dsPIC33EPXXXGP50X, dsPIC33EPXXXMC20X/50X and PIC24EPXXXGP/MC20X Family Silicon Errata and Data Sheet Clarification

The dsPIC33EPXXXGP50X, dsPIC33EPXXXMC20X/50X and PIC24EPXXXGP/MC20X family devices that you have received conform functionally to the current Device Data Sheet (DS70657E), except for the anomalies described in this document.

Data Sheet Clarifications

**64-Lead Plastic Quad Flat, No Lead Package (MR) – 9x9x0.9 mm Body
with 5.40 x 5.40 Exposed Pad [QFN]**

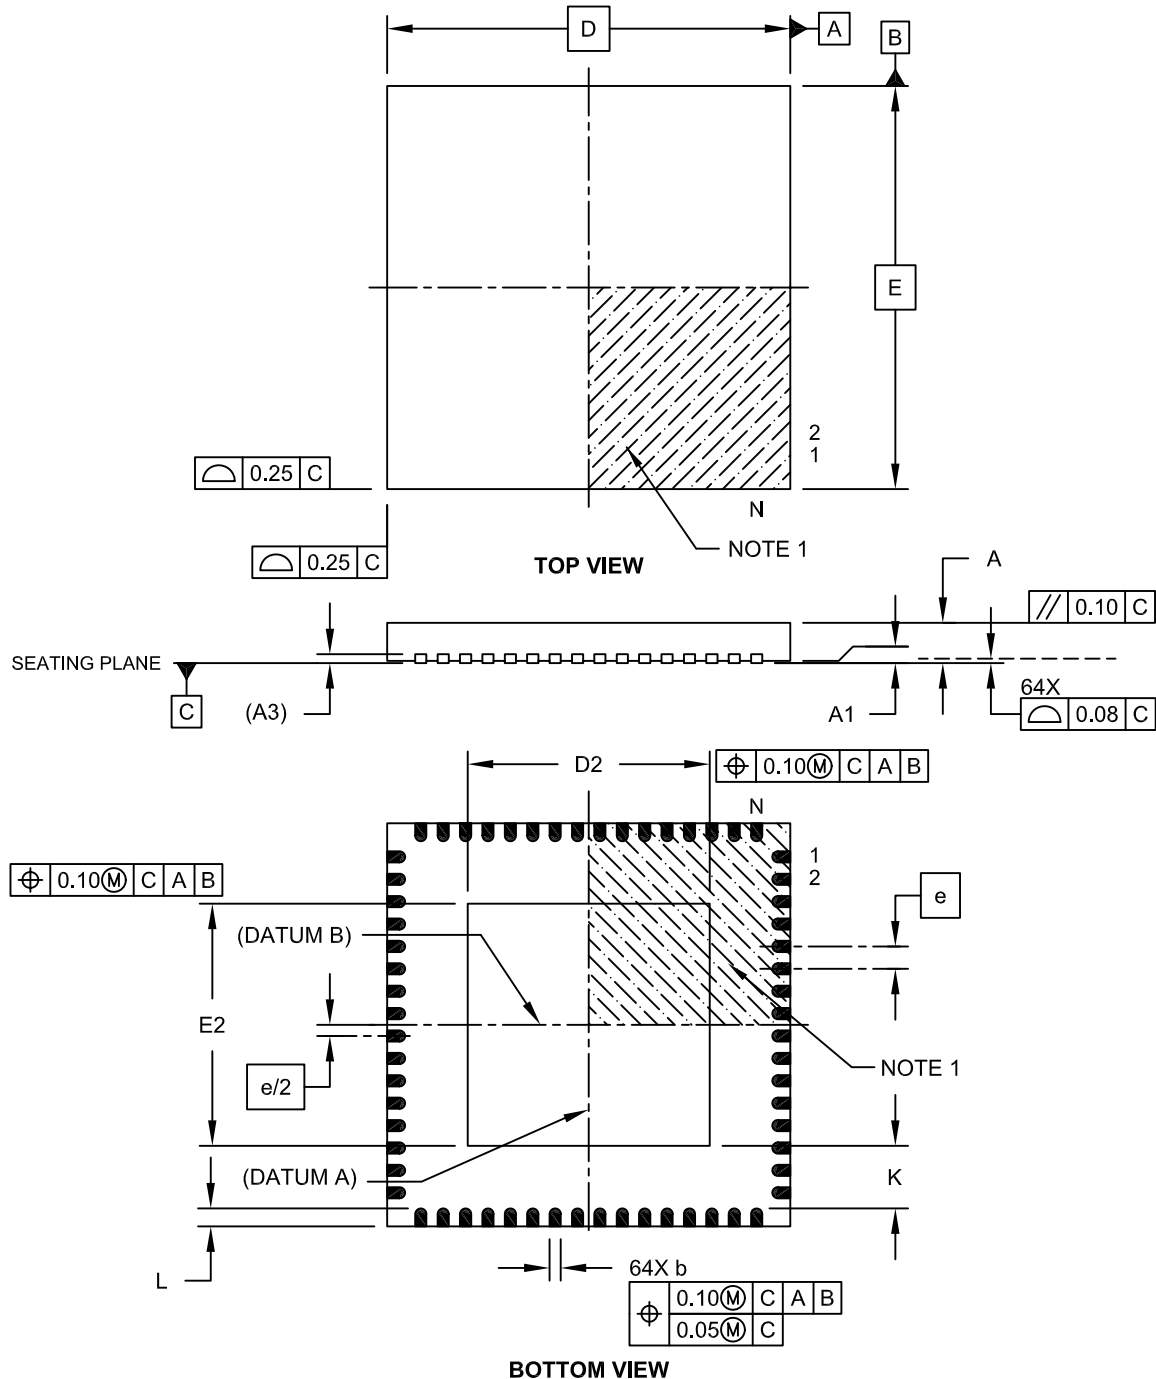
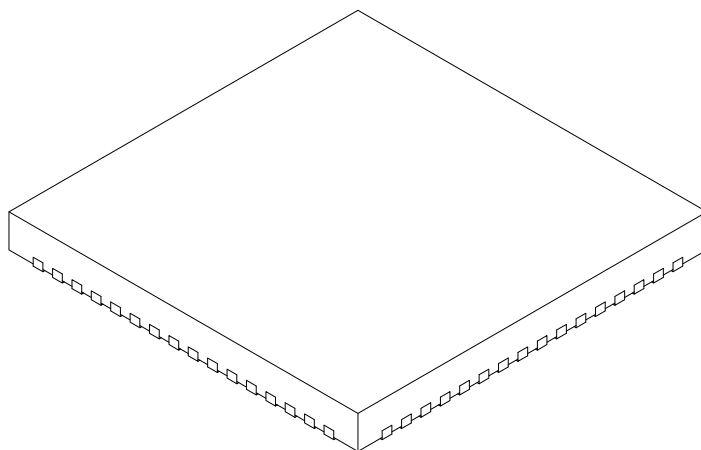
The device data sheet provides drawing C04-149C (2 pages) to describe the 64-pin QFN package for this family. The drawing indicates an exposed center pad of 7.15 mm x 7.15 mm nominal.

The actual packaging used for 64-pin QFN devices is described by drawing C04-154A (2 pages), which indicates an exposed center pad of 5.4 mm x 5.4 mm nominal. Key package dimensions (9 x 9 x 0.9 mm) are the same for both packages, as are the landing drawing (C04-2149A) and the board footprint.

The correct drawing, C04-154A, is shown on the following pages.
